737

Service Bulletin

Number: 737-26-1121
Original Issue: December 13, 2007
Revision 2: January 20, 2015
ATA System: 2616

SUBJECT: FIRE PROTECTION - Lower Cargo Compartment Smoke Detection - Installation of
Forward Cargo Compartment Smoke Penetration Sealing Provisions

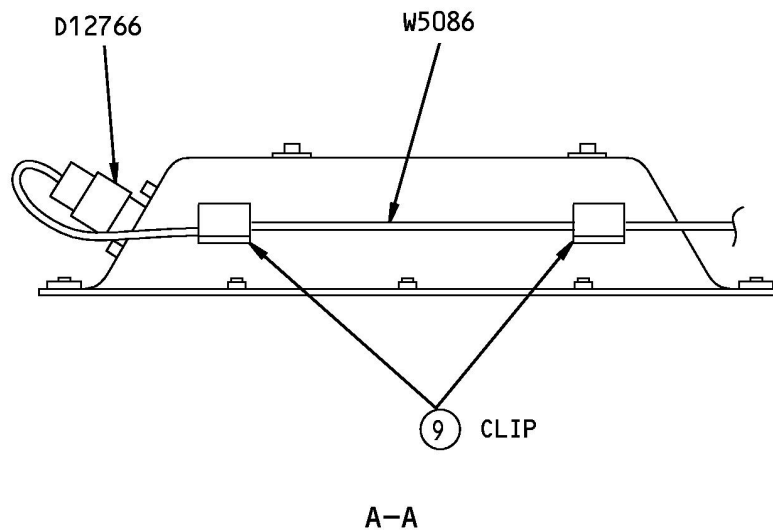
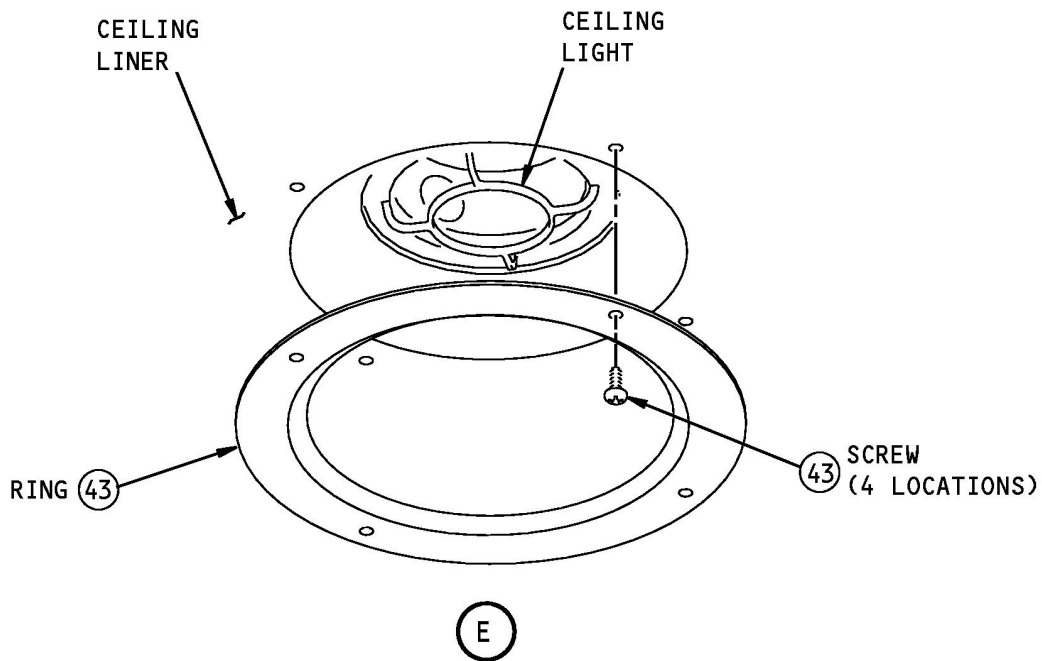
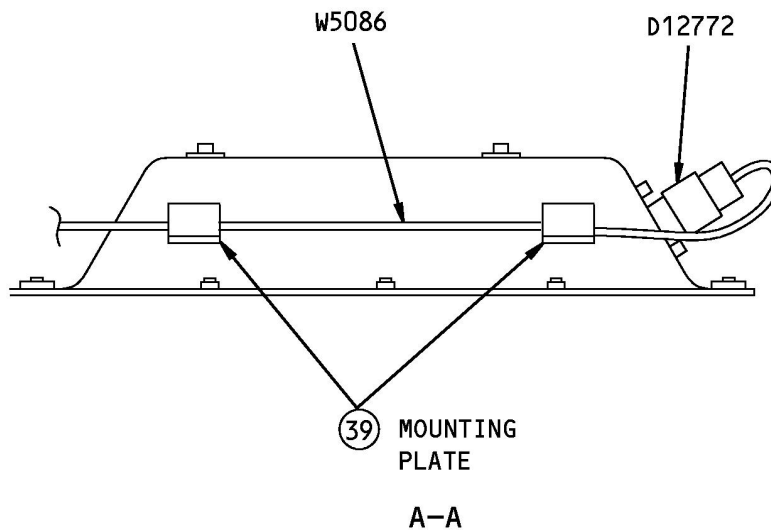
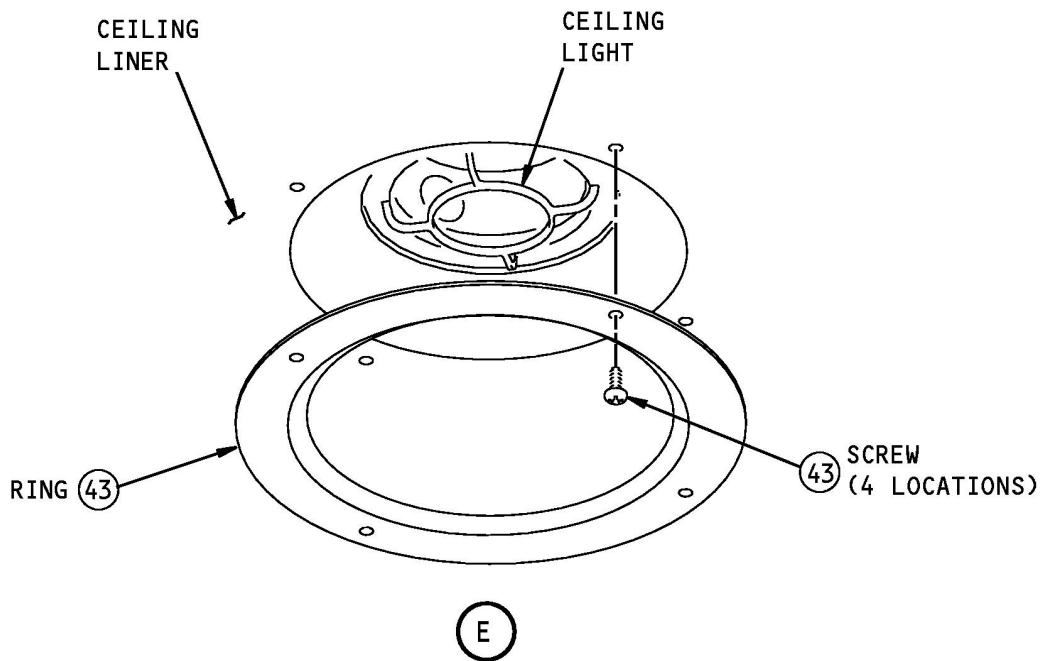
6. Paragraph 1.K.2. Damage Tolerance Based Structural Inspections paragraph does not exist.
7. Paragraph 2.C.1. Kits/Parts, Kit 287A4344-1, part number "022-0188", part name "Clip".
8. Paragraph 3.B. Work Instructions, Group 1, 4: Steps 7 and 8 are applicable to Groups 1 and 4.
9. Paragraph 3.B. Work Instructions, Group 1, 4: Step 15 is applicable to Groups 1 and 4.
10. Paragraph 3.B. Work Instructions, Group 2, 5: Steps 7 and 8 are applicable to Groups 2 and 5.
11. Paragraph 3.B. Work Instructions, Group 2, 5: Step 15 is applicable to Groups 2 and 5.
12. Paragraph 3.B. Work Instructions, Group 3, 6: Steps 7 and 8 are applicable to Groups 3 and 6.
13. Paragraph 3.B. Work Instructions, Group 3, 6: Step 15 is applicable to Groups 3 and 6.
14. FIGURE 2, sheet 6, the illustration appears as follows:

7. Paragraph 2.C.1. Kits/Parts, Kit 287A4344-1, part number "STBP19M10", part name "Mounting Plate".
8. Paragraph 3.B. Work Instructions, Group 1, 4: Steps 7 and 8 are applicable to Groups 1 and 4 Configuration 1.
9. Paragraph 3.B. Work Instructions, Group 1, 4: Step 15 is applicable to Groups 1 and 4 Configuration 2.
10. Paragraph 3.B. Work Instructions, Group 2, 5: Steps 7 and 8 are applicable to Groups 2 and 5 Configuration 1.
11. Paragraph 3.B. Work Instructions, Group 2, 5: Step 15 is applicable to Groups 2 and 5 Configuration 2.
12. Paragraph 3.B. Work Instructions, Group 3, 6: Steps 7 and 8 are applicable to Groups 3 and 6 Configuration 1.
13. Paragraph 3.B. Work Instructions, Group 3, 6: Step 15 is applicable to Groups 3 and 6 Configuration 2.
14. FIGURE 2, sheet 6, the illustration has changed as follows:

15. FIGURE 2, Step Table, Step 9, the part name is "Mounting Plate" and the identification is "STBP19M10".
16. FIGURE 6, sheet 6, the illustration has changed as follows:

16. FIGURE 6, sheet 6, the illustration appears as follows:

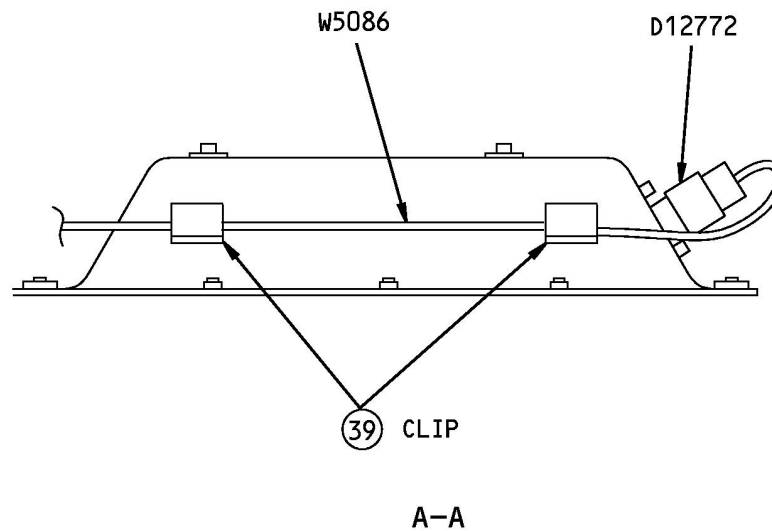
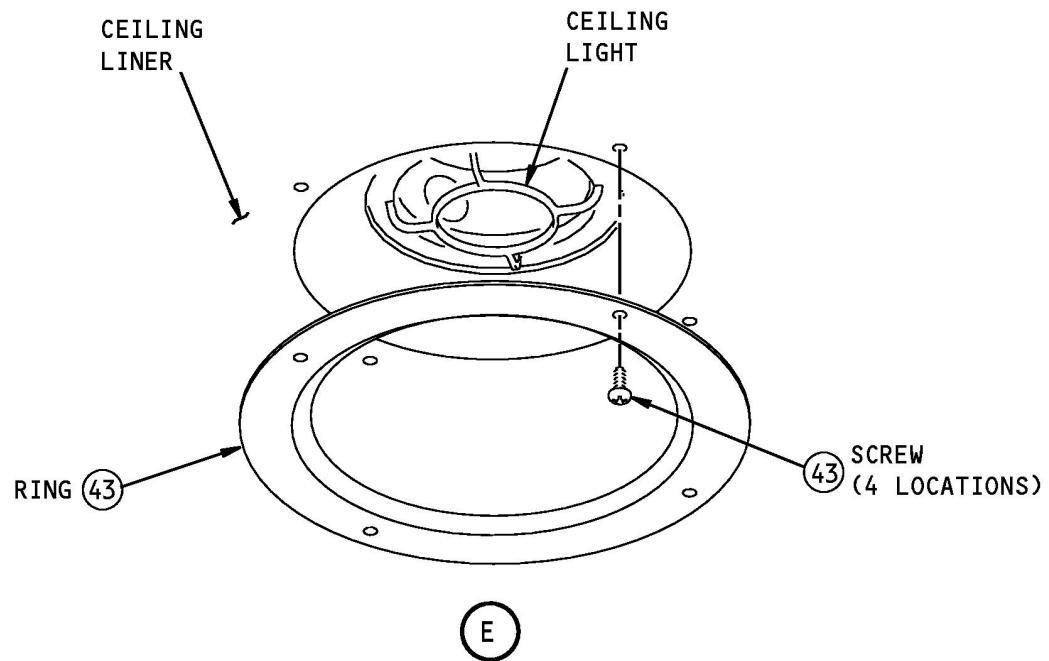
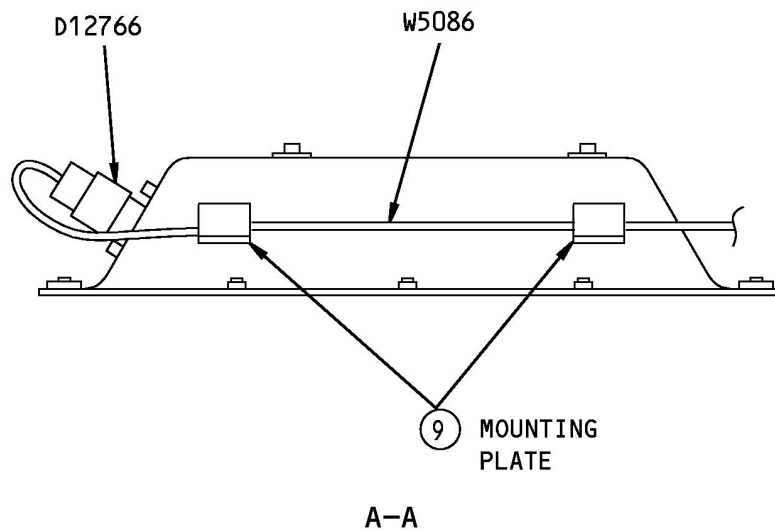
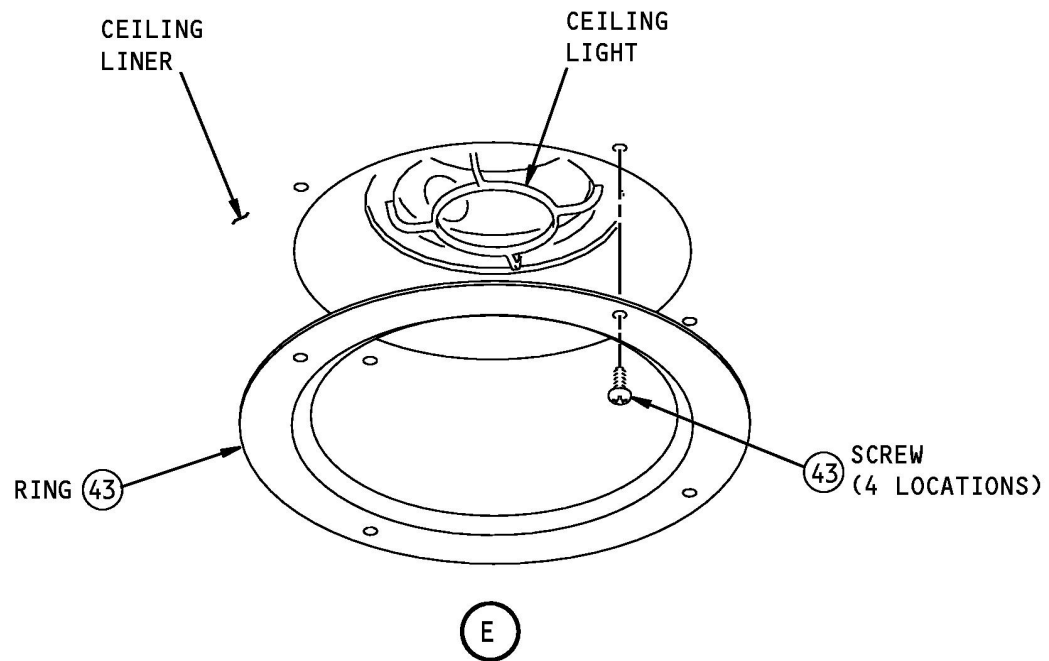
17. FIGURE 6, Step Table, Step 39, the part name is "Clip" and the identification is "022-0188".
18. FIGURE 20, Step Table, Step 12, the identification is "453A1121-7".
19. FIGURE 22, sheet 1, the illustration appears as follows:

17. FIGURE 6, Step Table, Step 39, the part name is "Mounting Plate" and the identification is "STBP19M10".
18. FIGURE 20, Step Table, Step 12, the identification is "453A1121-8".
19. FIGURE 22, sheet 1, the illustration has changed as follows:
